AT A REGULAR MEETING OF THE DEVELOPMENT REVIEW COMMITTEE OF THE  
COUNTY OF JAMES CITY, VIRGINIA, HELD IN THE BUILDING E CONFERENCE ROOM  
AT 4:00 P.M. ON THE 28TH DAY OF FEBRUARY, TWO THOUSAND ONE

**Staff Report for the March 28, 2001, Development Review Committee Meeting**

RE: SP-156-00 Monticello at Powhatan, Phase II

ENVIRONMENTAL DIVISION REVIEW COMMENTS  
MONTICELLO AT POWHATAN APARTMENTS (PHASE 2)

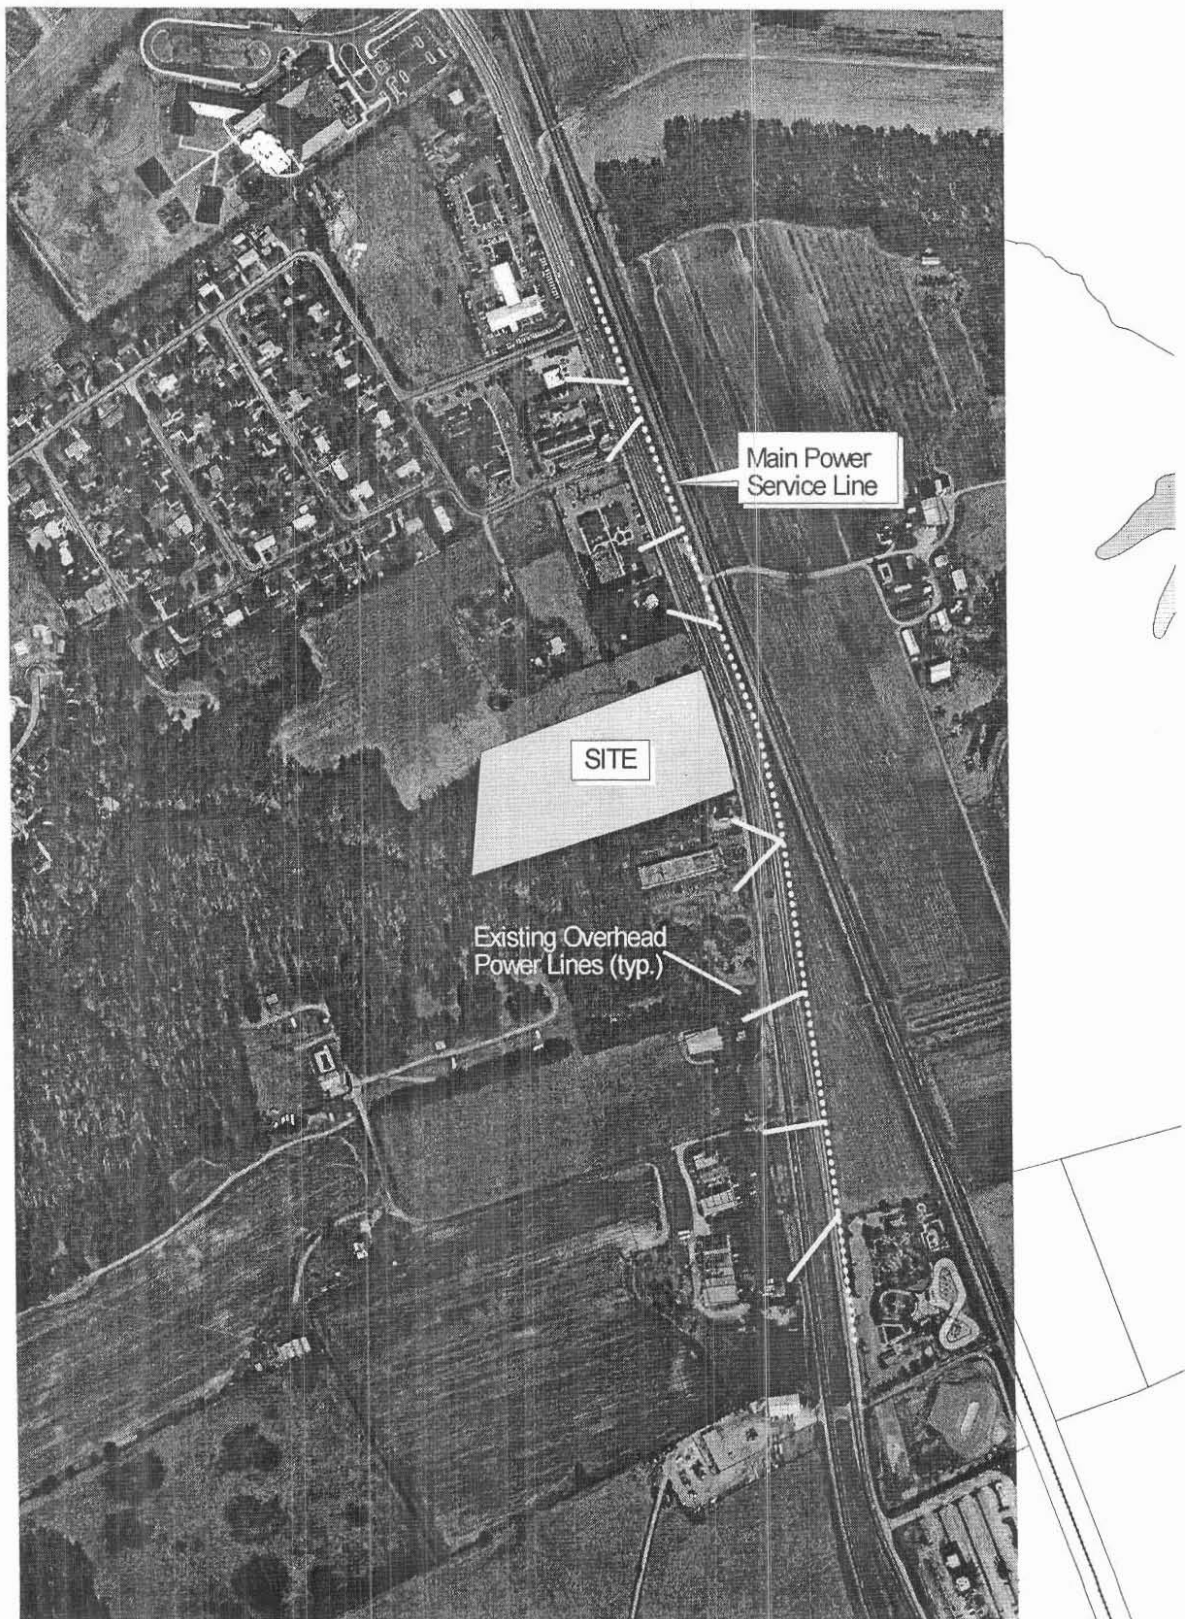
MR. CENTER SUGGESTED THAT SINCE THAT THE POLE WITH THE OVERHEAD LINE WAS DIRECTLY IN FRONT OF THE NEW DEALERSHIP THAT WE MOVE IT TO THE SOUTHWEST CORNER OF THE PROPERTY WHICH IS SHOWN IN PICTURE LABELED #1. PICTURES #2 AND #3 SHOW THE POLE AND TRANSFORMERS AS THEY NOW EXIST. THE LINE FROM THE POLE TO THE NEW BUILDING IS ALREADY INSTALLED UNDERGROUND. THIS WAS DONE IN ORDER THAT WE COULD GRADE THE AREA AND INSTALL OUR IRRIGATION SYSTEM, WHICH HAS BEEN DONE.

OUR REQUEST IS THAT WE BE ALLOWED TO CONNECT AN OVERHEAD LINE FROM THE POLE ON THE EAST SIDE OF RICHMOND ROAD TO THE WEST SIDE. TO REQUIRE US TO TAKE THE ENTIRE SYSTEM UNDERGROUND WOULD REQUIRE VIRGINIA POWER TO DISMANTLE THE EXISTING POLE AND TRANSFORMERS AND DISRUPT THE AREA WHICH HAS ALREADY BEEN GRADED AND OTHER IMPROVEMENTS INSTALLED. NEEDLESS TO SAY THIS WOULD CAUSE CONSIDERABLE TROUBLE AND EXPENSE.

SINCE AN OVERHEAD LINE ALREADY EXISTED WHAT WE PROPOSE WOULD CAUSE NO ADDITIONAL LINES TO BE CONSTRUCTED. VIRGINIA POWER HAS FELT FROM THE BEGINNING THAT THE ORDINANCE REQUIRING UNDERGROUND SERVICE WAS NOT APPLICABLE BECAUSE THEY HAD TREATED THE PROJECT AS A SERVICE UPGRADE AND NOT A NEW SERVICE.
